# City of Fairfax, Virginia

## City Council Work Session

SUBJECT: Joint discussion with the Planning Commission regarding a request of IDI, Inc. to discuss the potential application for the redevelopment of the Paul VI site.

**ISSUE(S):** Informational Work Session of City Council to discuss initial concepts for the proposed redevelopment of the Paul VI High School site. Although a formal application has not yet been submitted, the applicant has prepared two design concepts for discussion. Initial feedback is sought by City Council regarding preferences between aspects of the two concepts, as well a general feedback on the proposed program and site layout.

**Figure 3: Building area proposed for preservation**

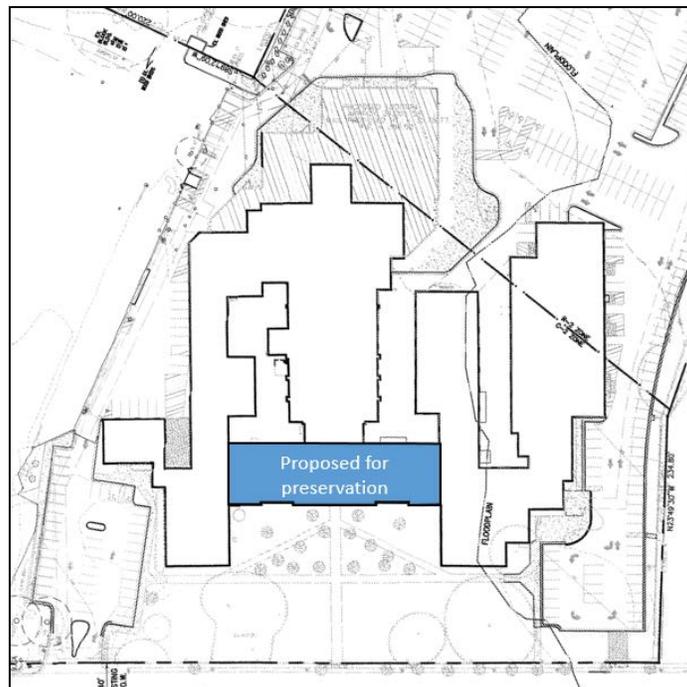
Since construction of the original portion of the Fairfax High School building, multiple additions have occurred. If the applicant proceeds with Scheme B, which has a preservation and adaptive reuse component as described above, then restorative work and modifications would be required to the structure. An adaptive reuse study and historic structures report on the building by a qualified architect specializing in historic architecture would be expected prior to a public hearing to ensure that the building could be modified without substantial alteration to the exterior integrity.
